# Bird Sculpture for The Randall Museum

Ben Trautman Trautman & Associates April 20th, 2016

STRUCTURAL NARRATIVE
FOR RANDALL MUSEUM INSTALL
BY BEN TRAUTMAN
SAN FRANCISCO, CA
APRIL 8, 2016
JOB NO. 15229.10

RANDALL MUSEUM INSTALLATION - BEN TRAUTMAN

### Plan view of 50% scale model

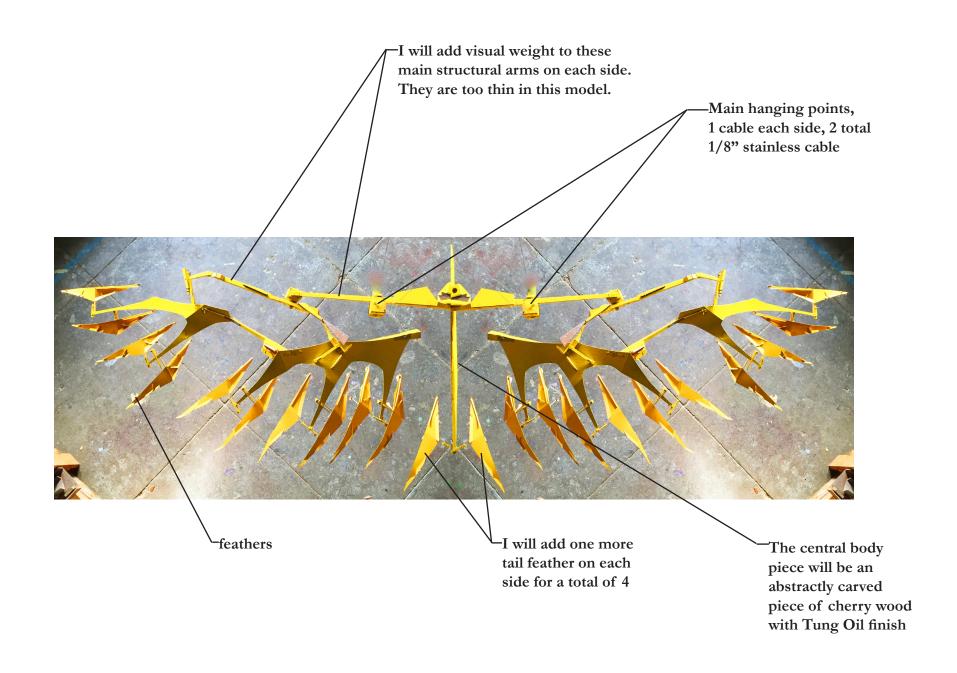
As stated previously, the overall dimensions have been adjusted to ensure proper clearances from walls and floors.

Original dimensions in mockup: 20' x 8'

New dimensions: 19' x 6'

# Drawing placed in Lobby plan

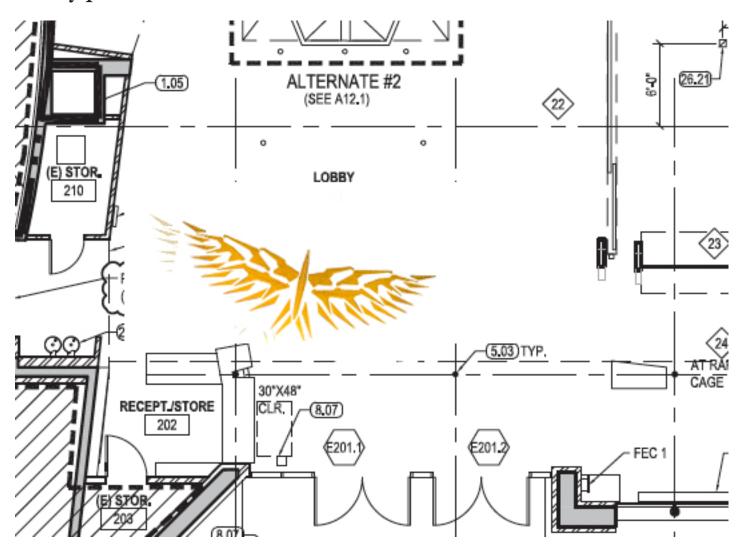
On March 3, I brought the full scale drawing to the Randall with a laser level to locate the hanging points up from the floor to check the placement relative to the exposed ceiling beams On April 7th, I returned to verify clearances and, with approval from Randall Staff, I adjusted the placement, moving it to the right by about 1 foot. The ghost image of the left wing tips represents the previous location.

Clearance to clearstory wall, 36"

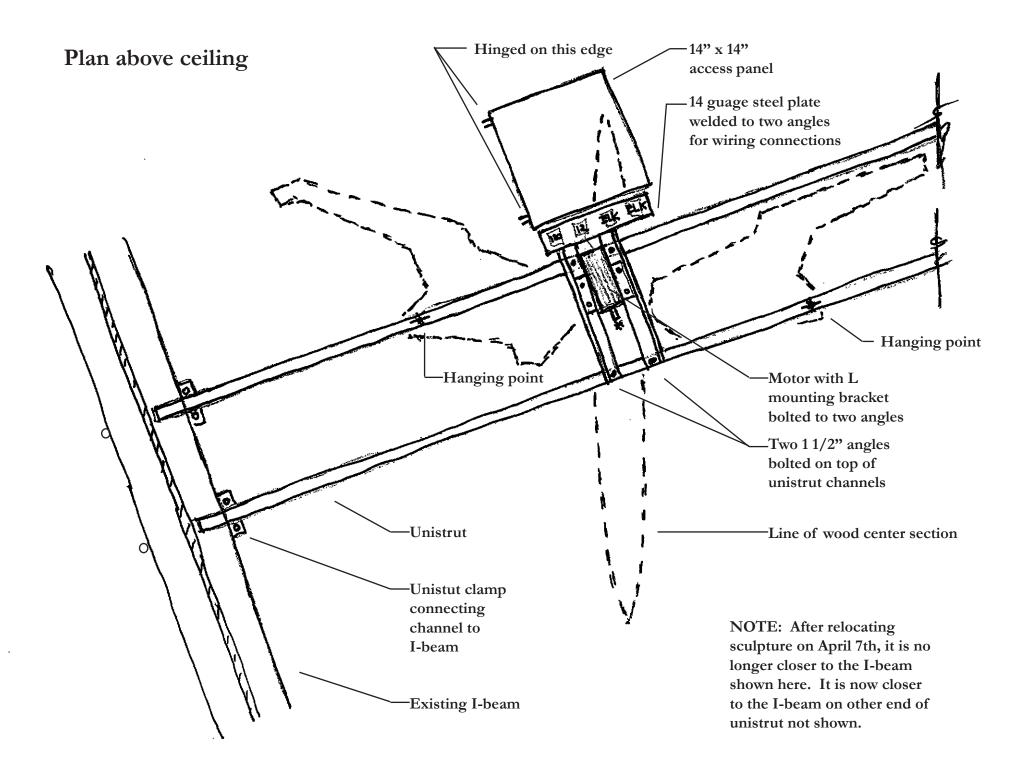
We recommend that the sculpture maintain a 3'-0" clearance from the surrounding walls/partitions to allow for the anticipated sway during a design-level seismic event (10% chance in 50 years). However, even should the seismic motions exceed the calculated values, the feathers that impact the adjacent partitions would simply unseat and should not represent a life-safety hazard.
